RACE CODE
METHODOLOGY AND VERIFICATION

Additional Information in Response to Question 1.

Figure 1.1

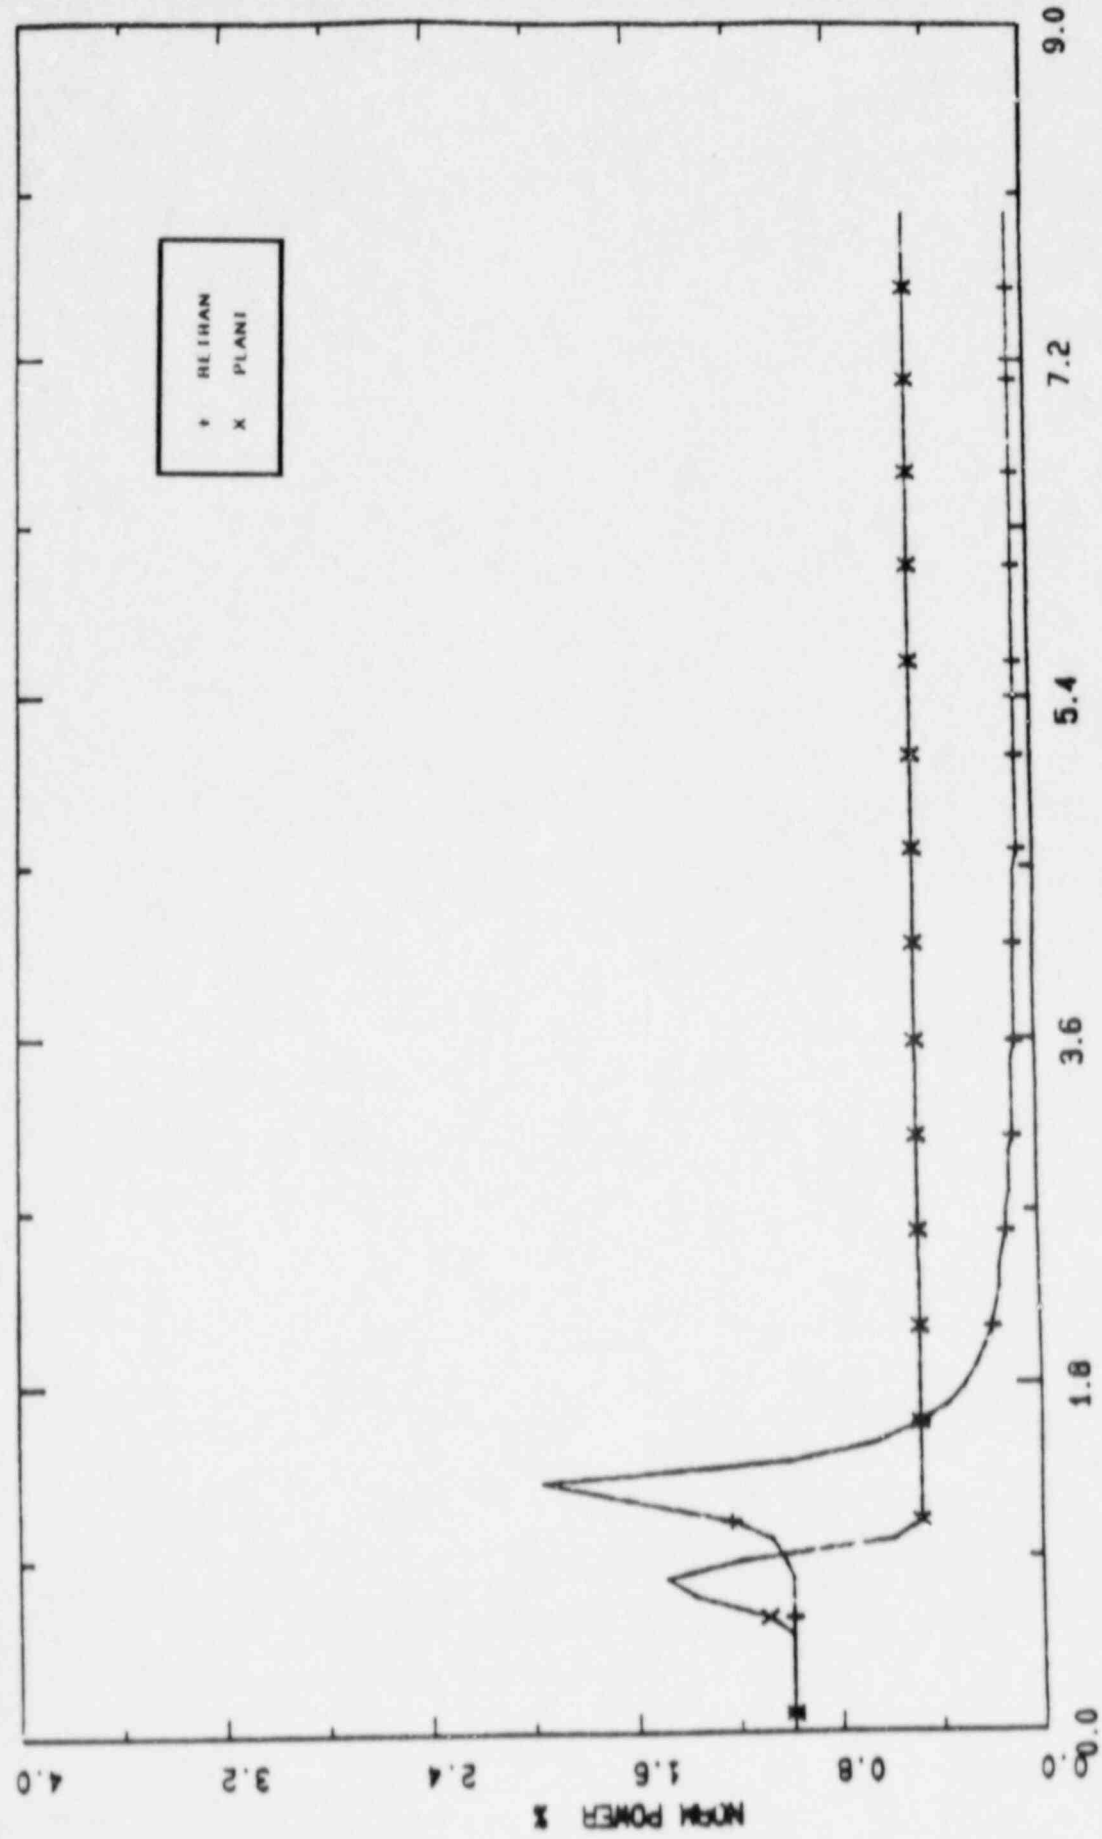
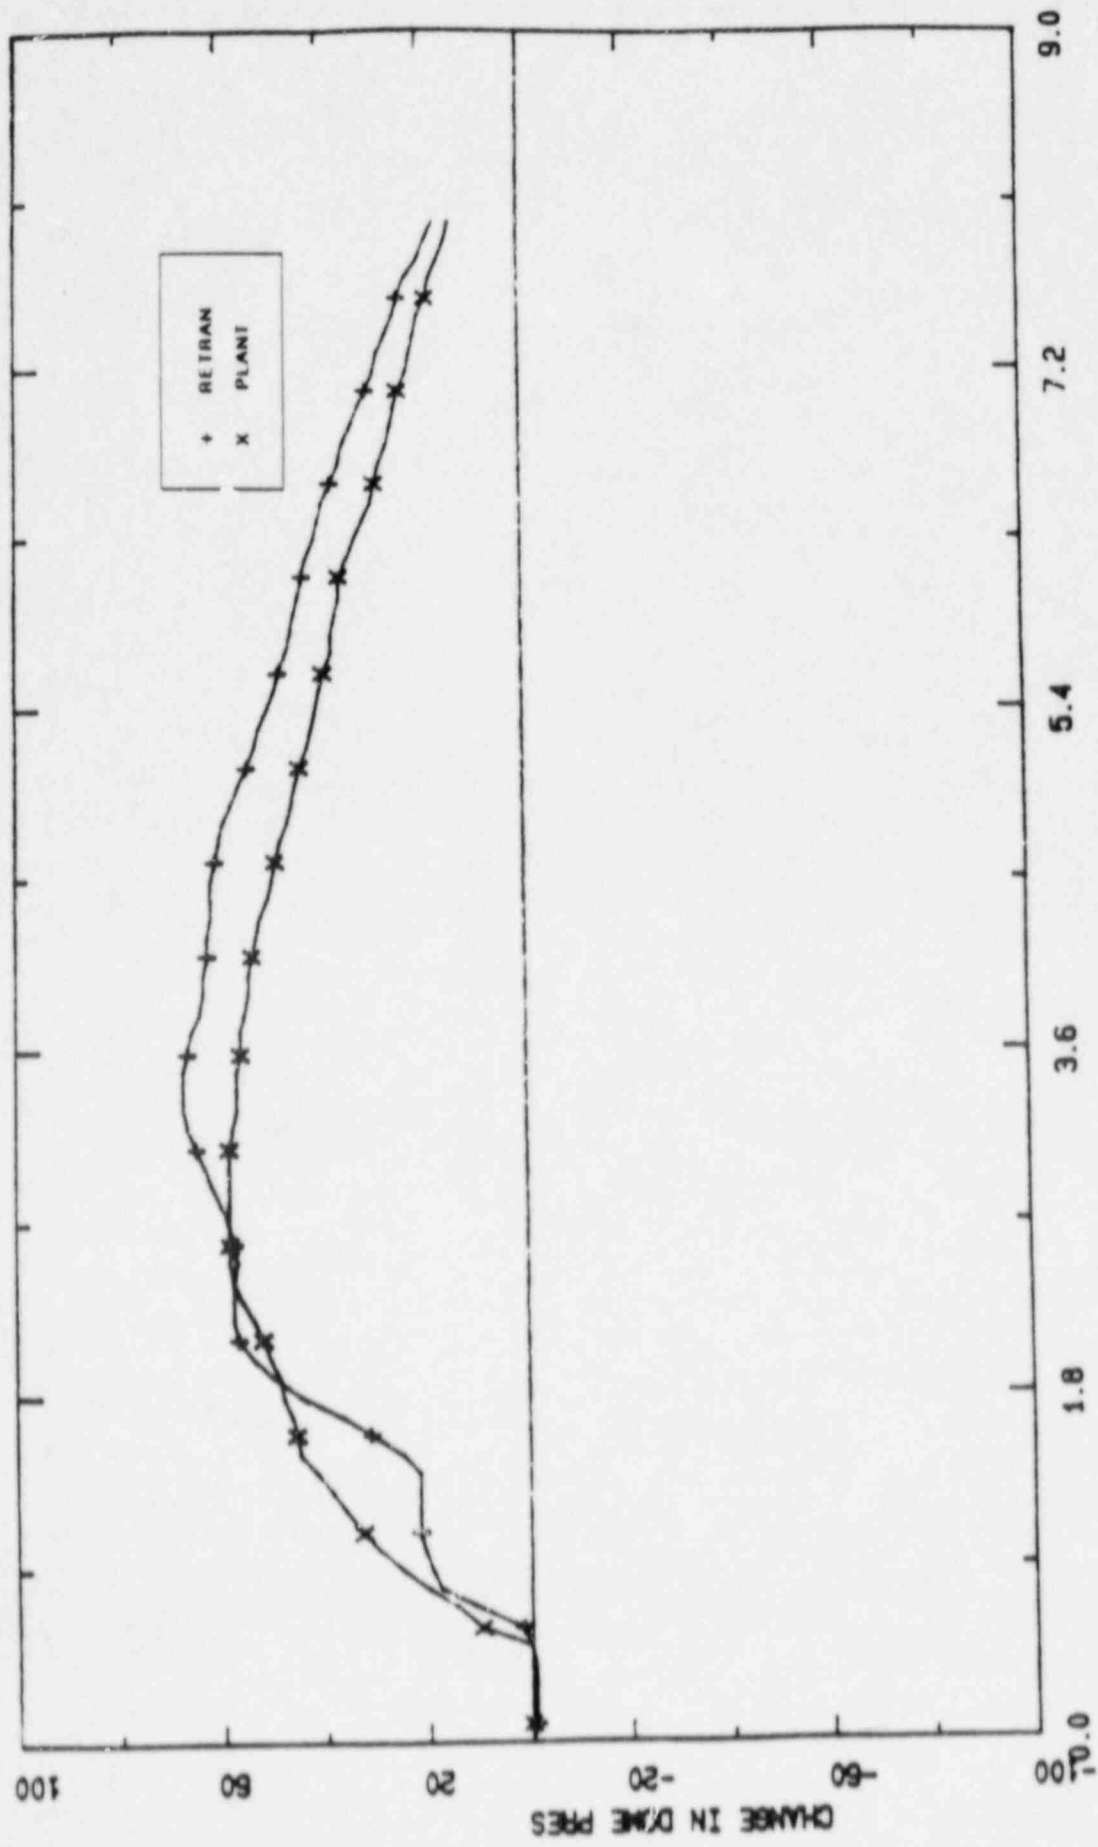
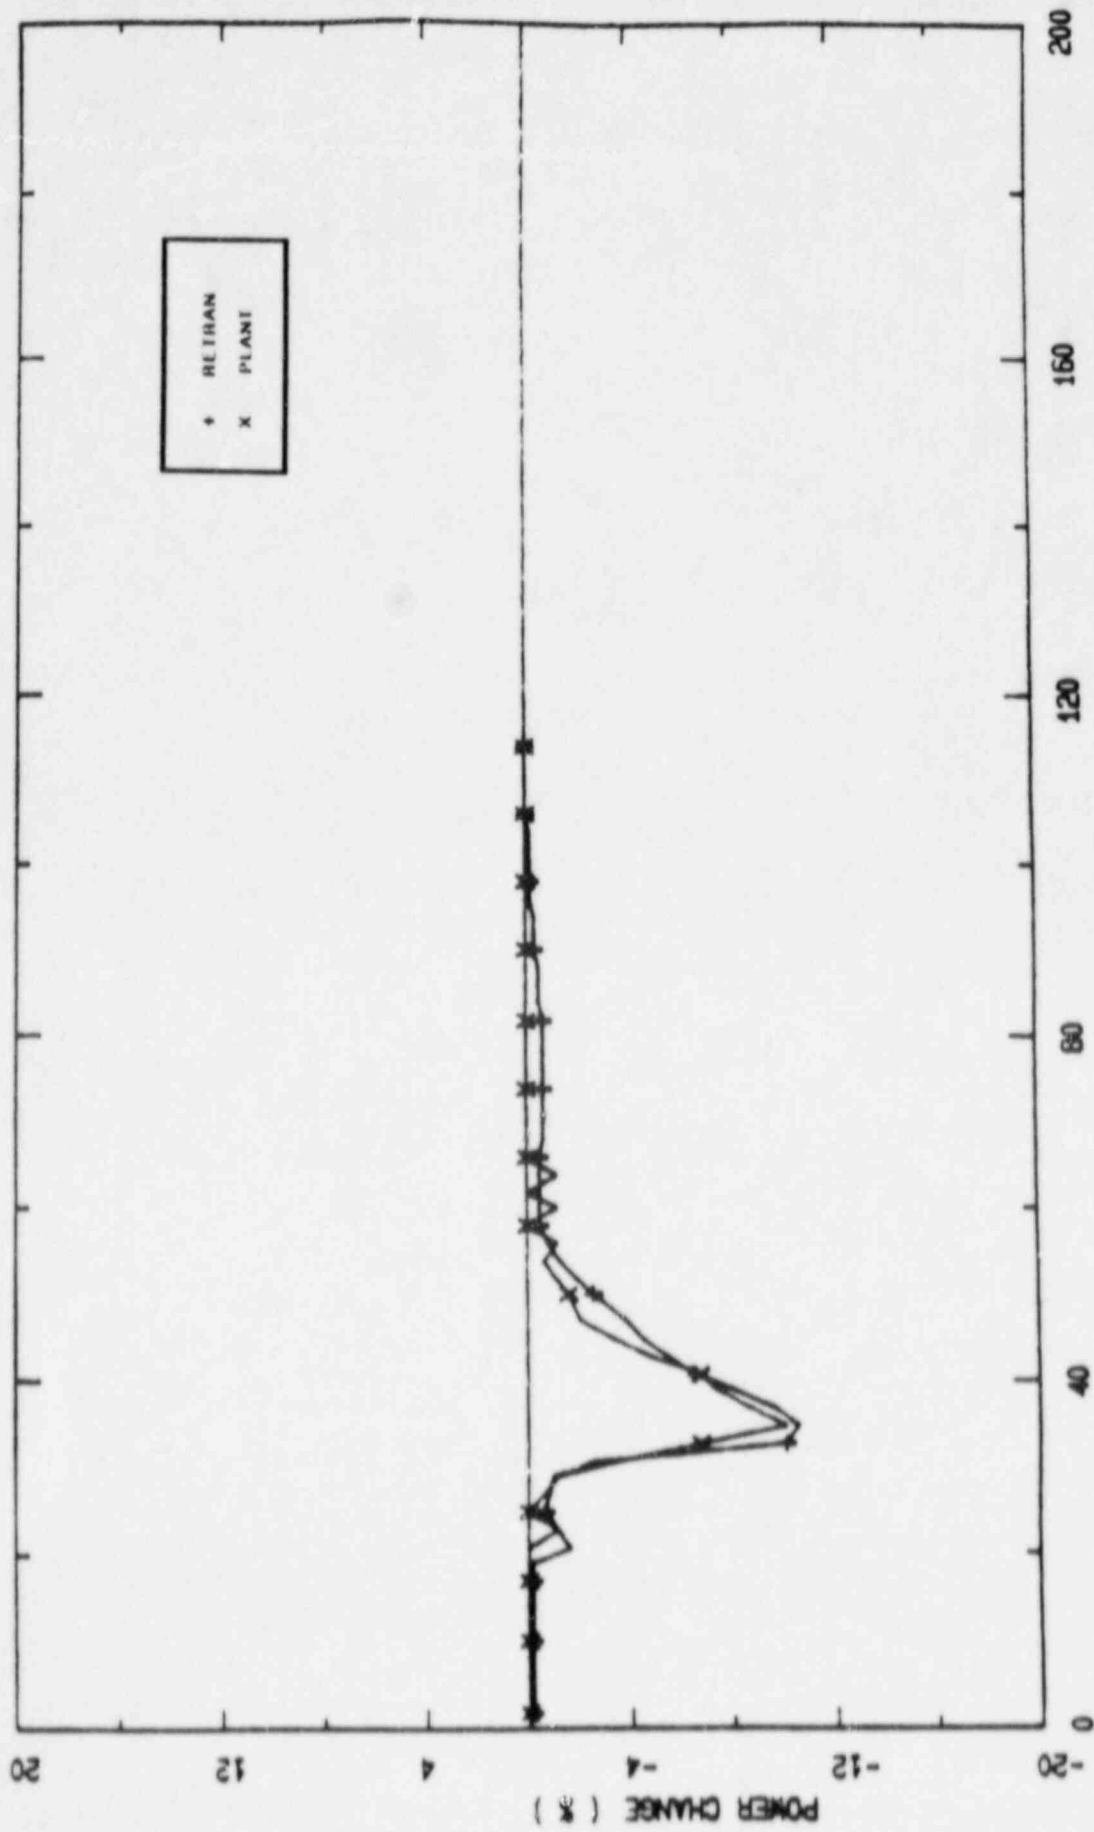
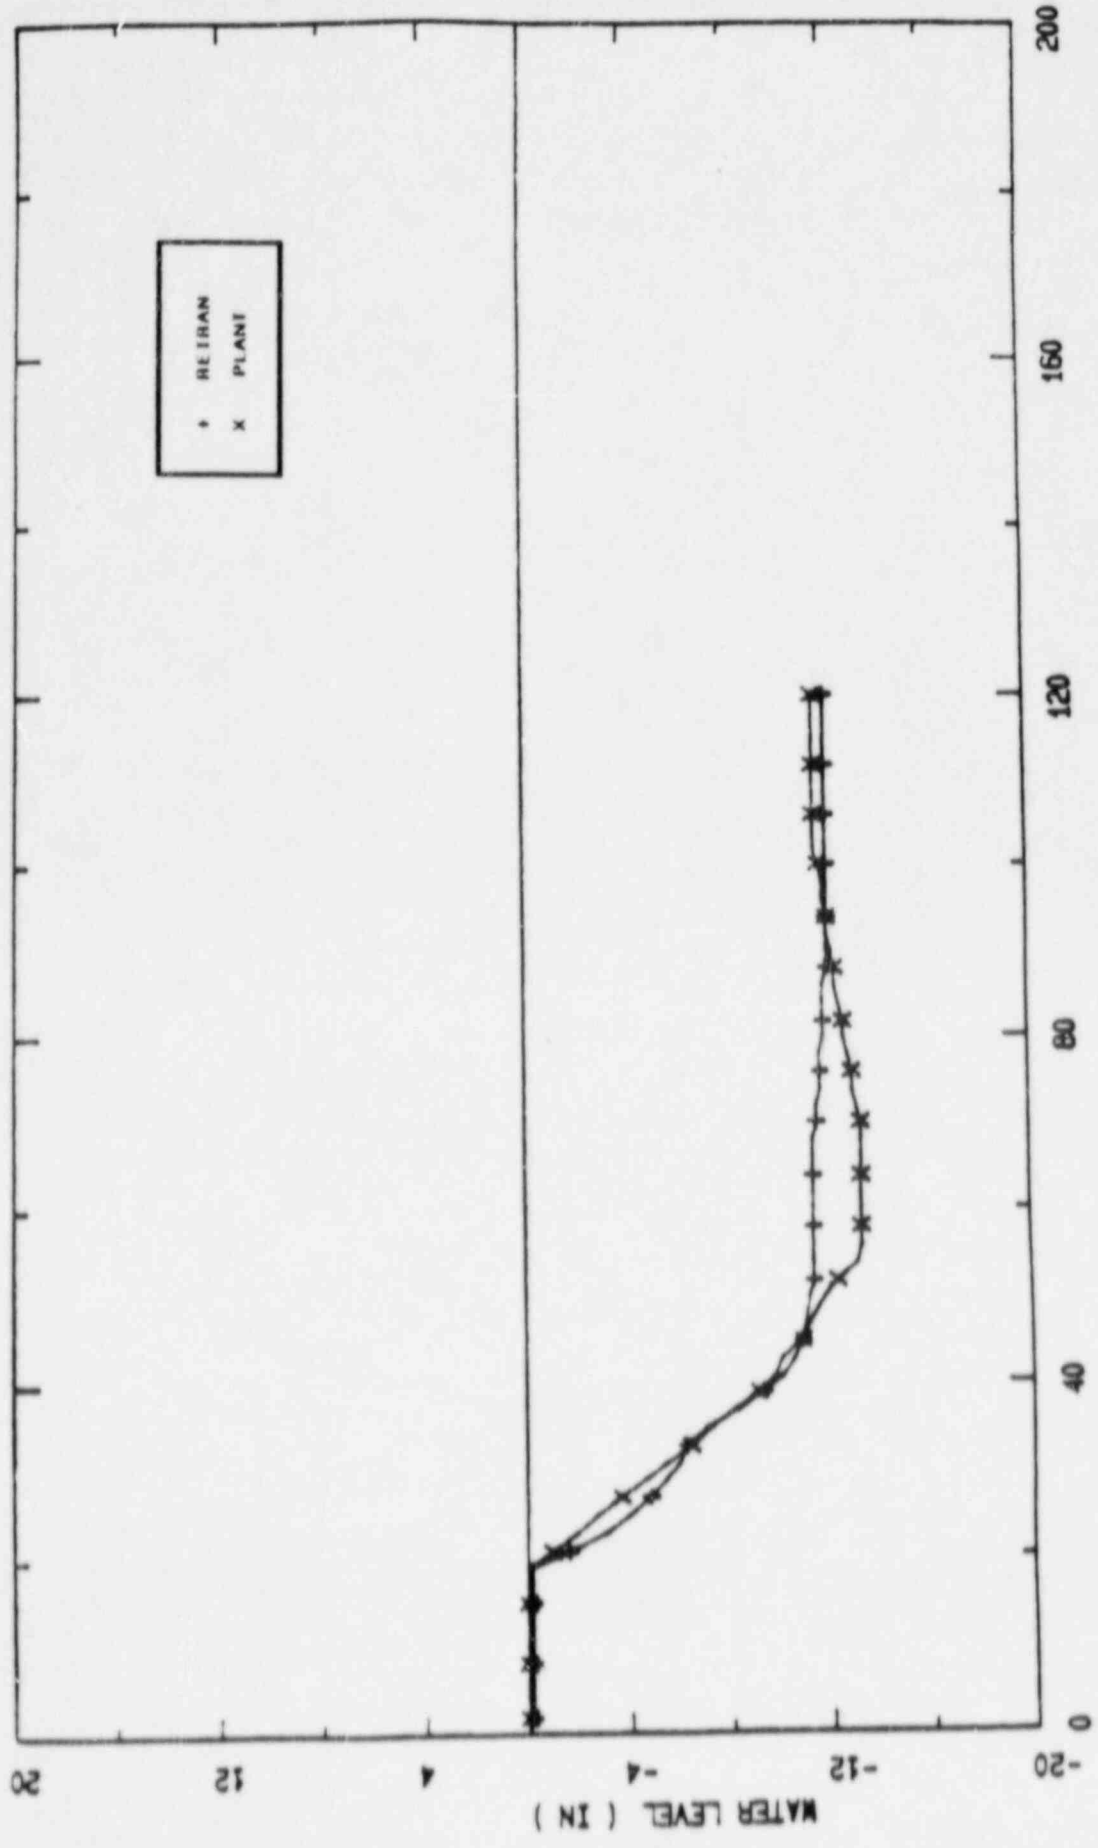
Four startup tests have been reanalyzed using the algebraic slip option (as opposed to the dynamic slip originally used). Those tests were the level setpoint change, the pressure setpoint change, turbine trip and the generator trip. Those tests cover the small perturbations to the severe pressurization conditions. Results presented in figures 1.1 - 1.8 show that the algebraic slip gives results comparable to the dynamic slip in comparison to plant data. Furthermore, use of the algebraic slip model in the context of GPUNs overall RETRAN modeling, provides a more conservative result (in terms of ΔCPR) than the current licensing model (ODYN) for the reload transients analyzed (see Table 1.1). An additional model uncertainty has been included for use of algebraic slip and is discussed with the additional information provided for questions 15 and 21. As such, the use of the algebraic slip model is acceptable for its intended application.
